FORT EUSTIS, VA

MH 116

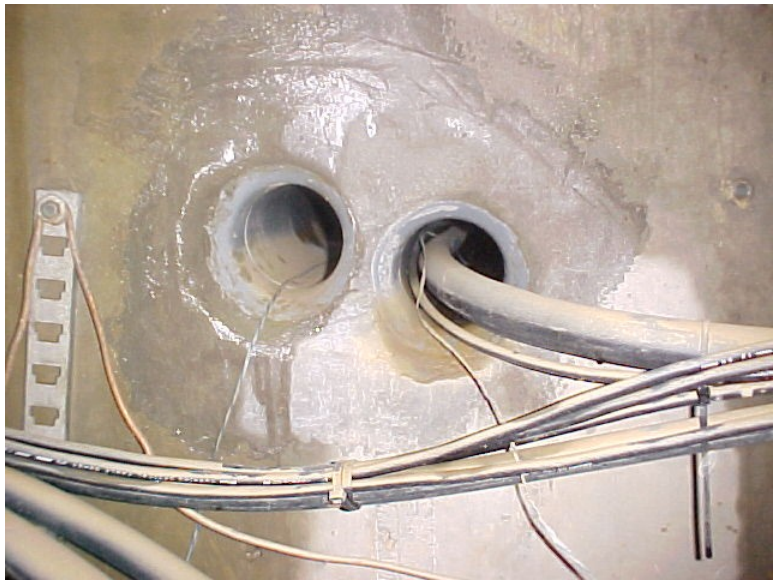
Incorrect grounding,
Incorrect racks and racking,
Incorrect duct placement, and
Incorrect masonry work.
Duct not lined up and not level.
No duct plugs.

Tree planted in duct line.

Bldg 860

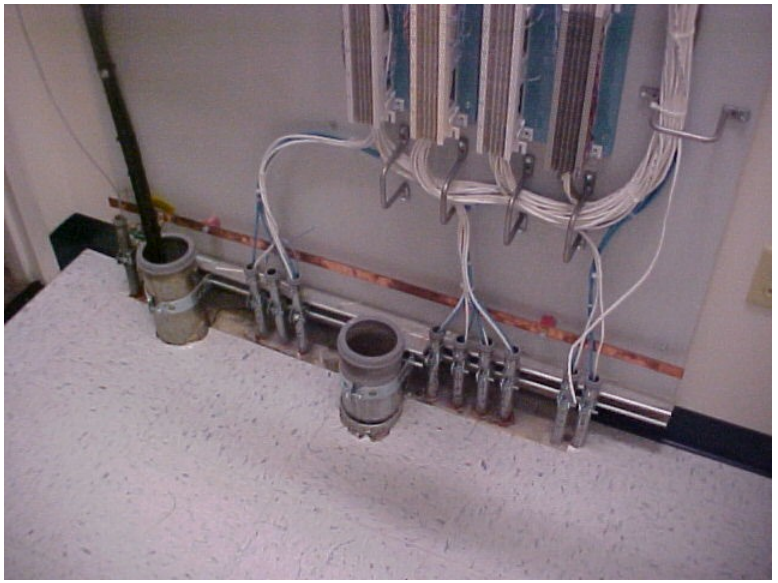
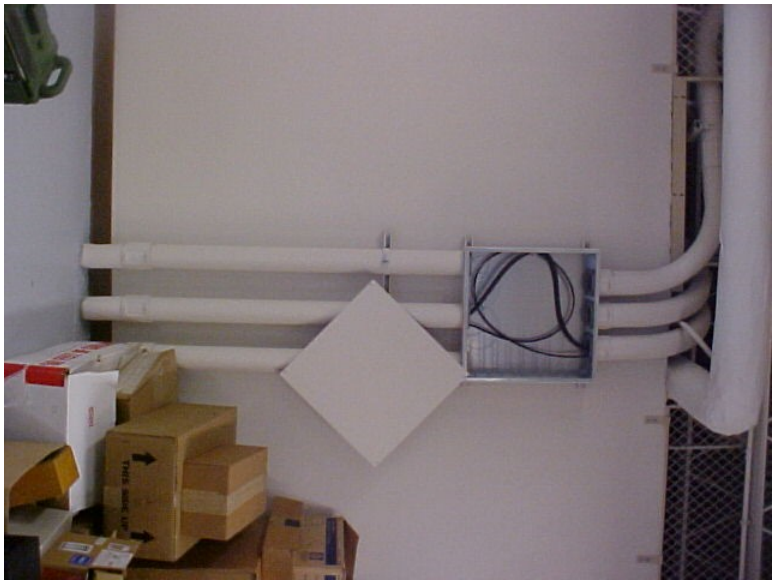
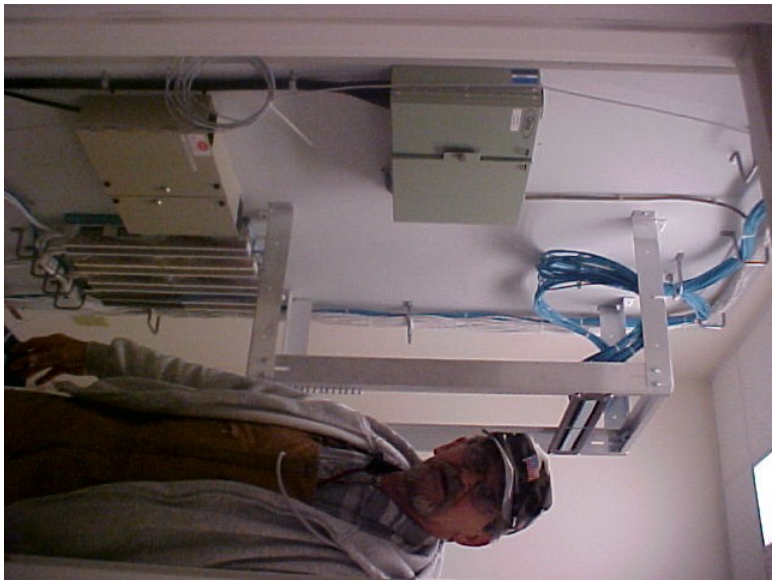
Two duct goes to the MH, one stubs out five feet.
Two duct go through the floor on one side of the Comm Rm and one on the other.

MH 33

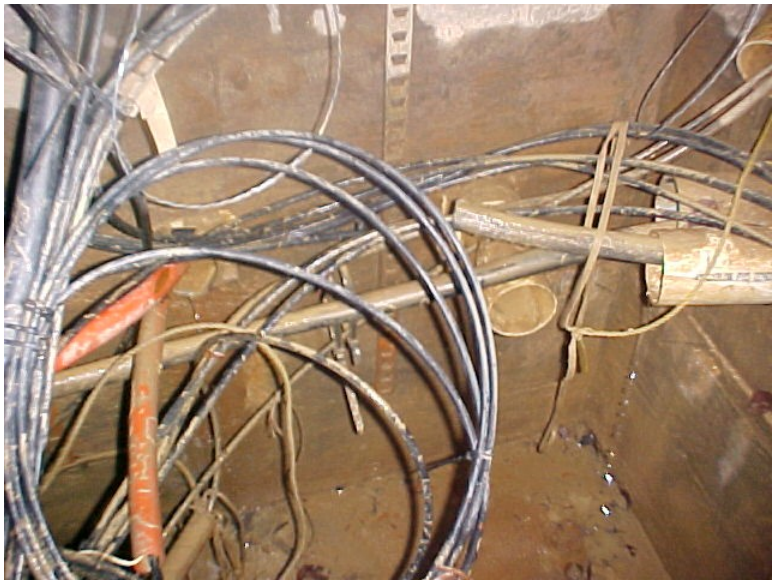
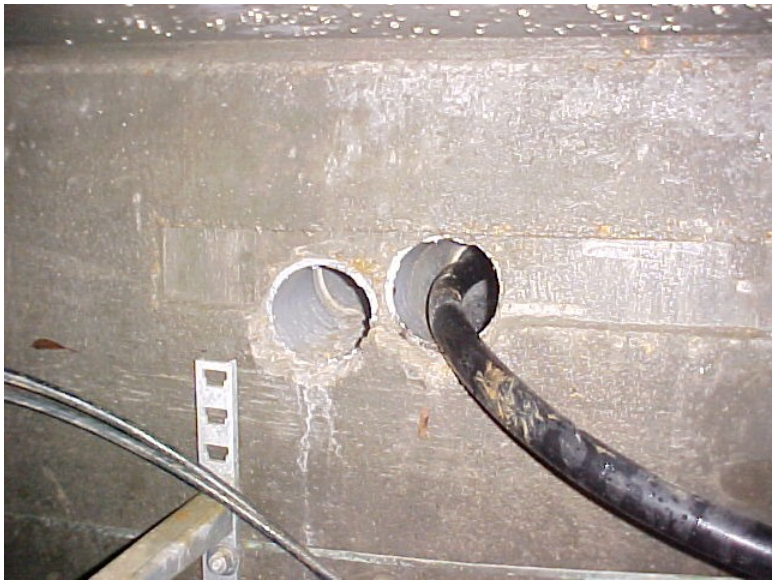
Incorrect grounding,
Incorrect racks and racking,
Incorrect duct placement, and
Incorrect masonry work with slipped collar.
Duct not lined up and not level.
No duct plugs.

MH 33

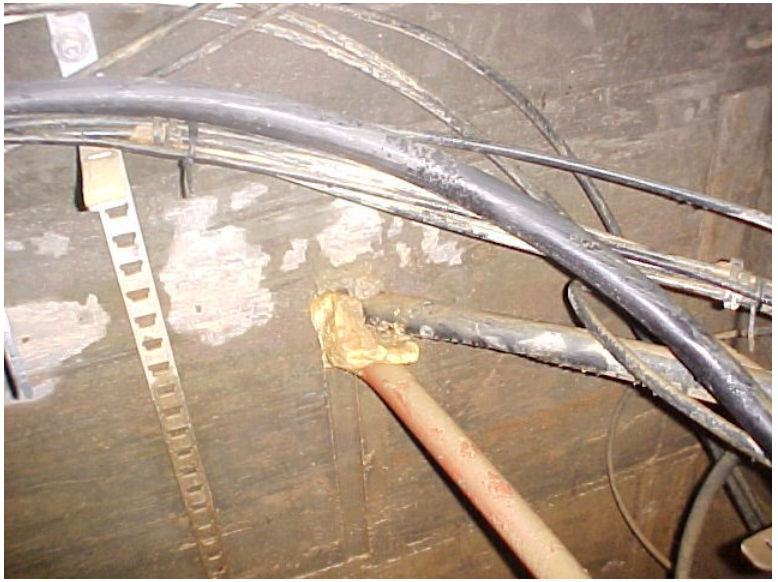
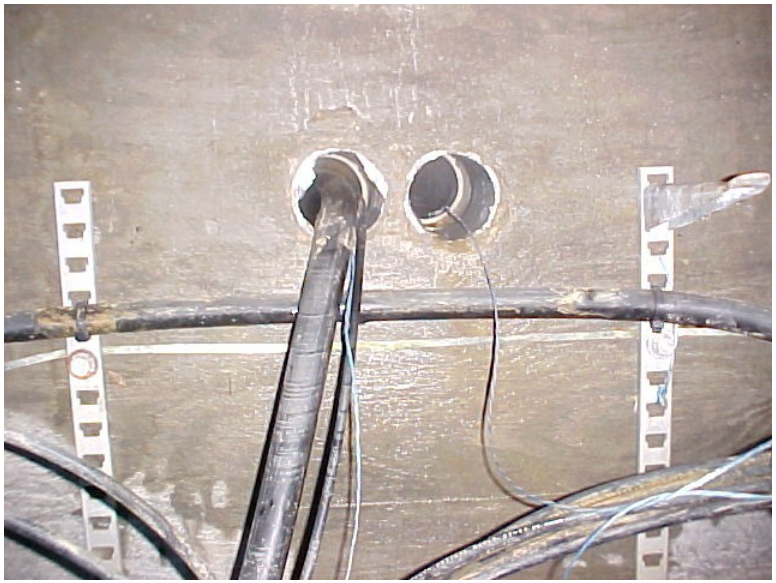
Incorrect grounding,
Incorrect racks and racking,
Incorrect duct placement, and
Incorrect masonry work with slipped collar.
Duct not lined up and not level.
No duct plugs.

MH 92

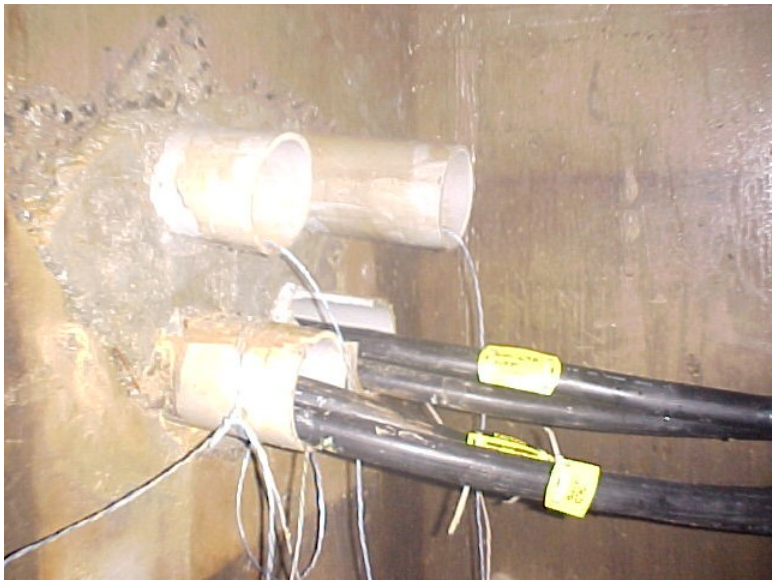
Incorrect grounding,
Incorrect racks and racking,
Incorrect duct placement, and
Incorrect masonry work with slipped collar.
Duct not lined up and not level.
No duct plugs.
Collar not lined up with hole.

MH 92

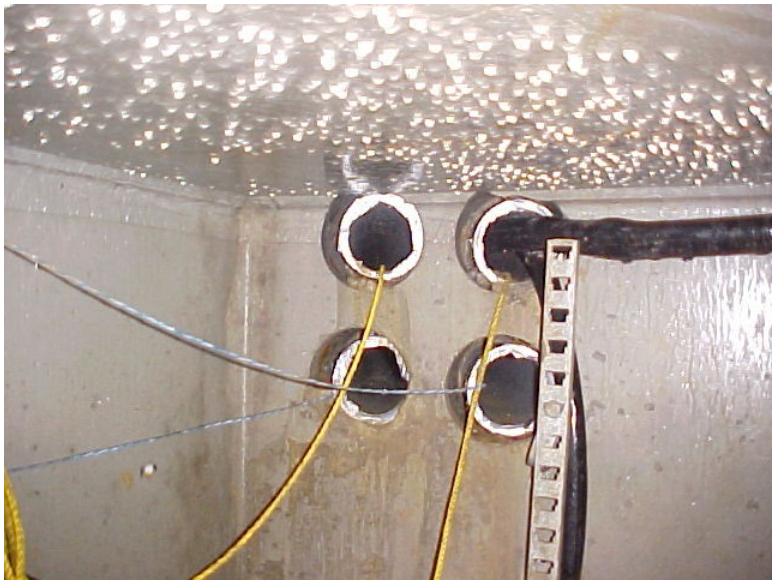
Incorrect grounding,
Incorrect racks and racking,
Incorrect duct placement, and
Incorrect masonry work with slipped collar.
Local telco has installed poured splice-cases.
Core drills are to high and either point up or down.

MH 81

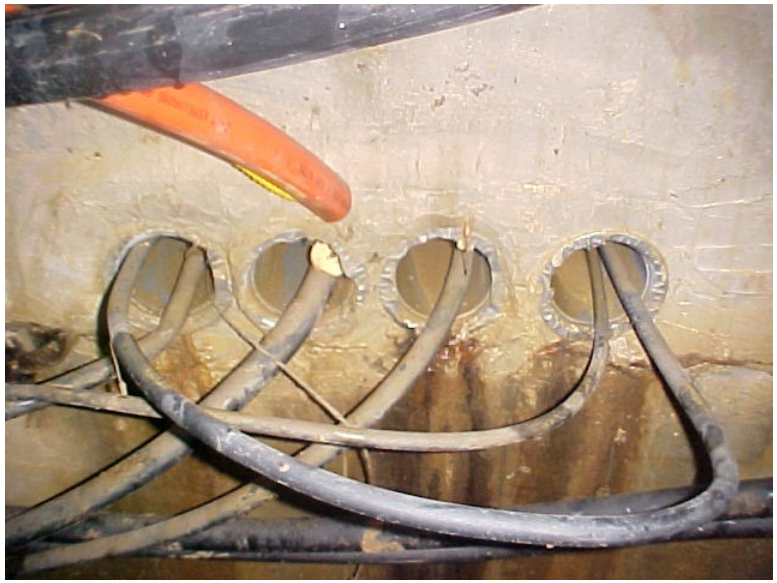
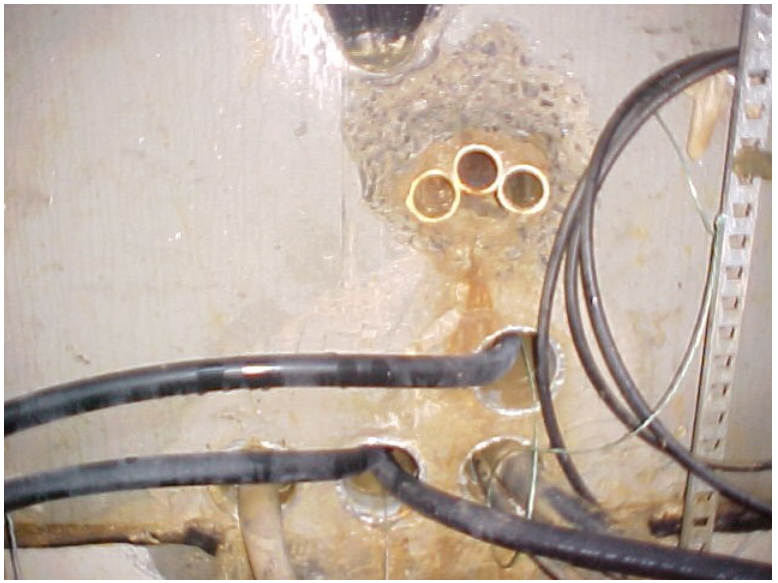
Incorrect grounding,
Incorrect racks and racking,
Incorrect duct placement, and
Incorrect masonry work with slipped collar.
Duct not lined up and not level.
No duct plugs.

MH 93

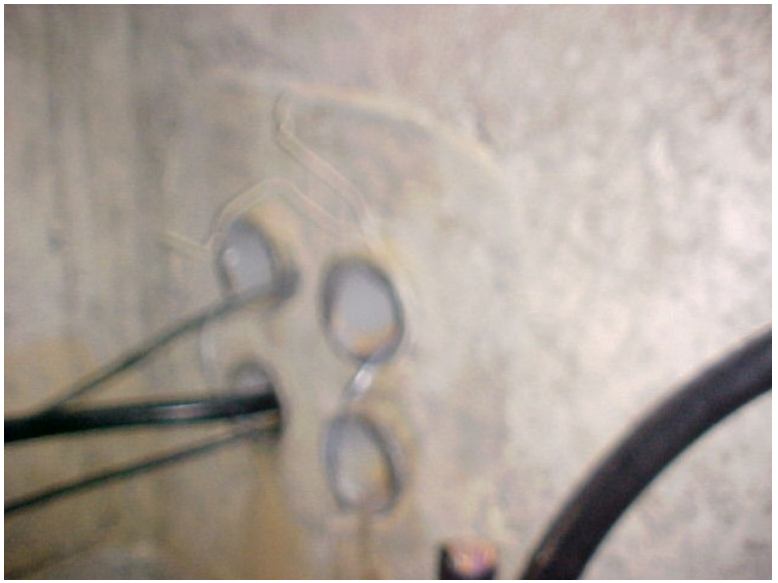
Incorrect grounding,
Incorrect racks and racking,
Incorrect duct placement, and
Incorrect masonry work with slipped collar.
Duct not lined up and not level.
No duct plugs.

MH 93

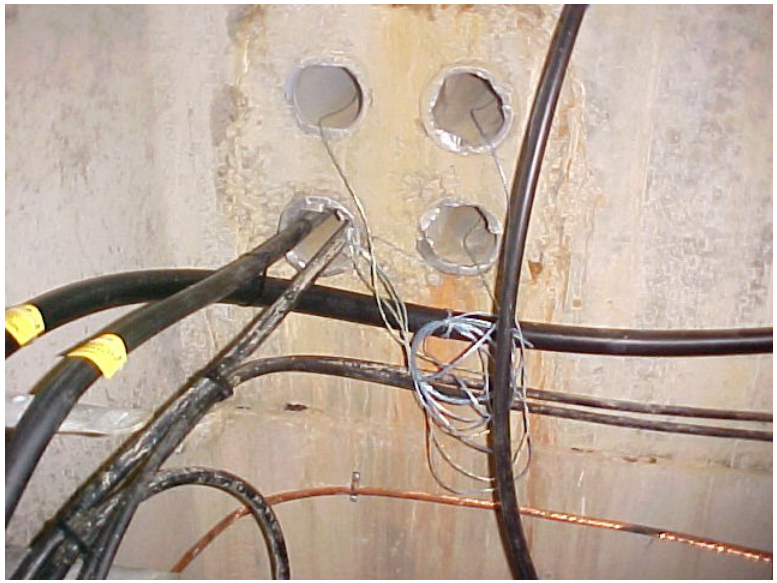
Incorrect grounding,
Incorrect racks and racking,
Incorrect duct placement, and
Incorrect masonry work with slipped collar.
Duct not lined up and not level.
No duct plugs.
Duct to close to the ceiling.
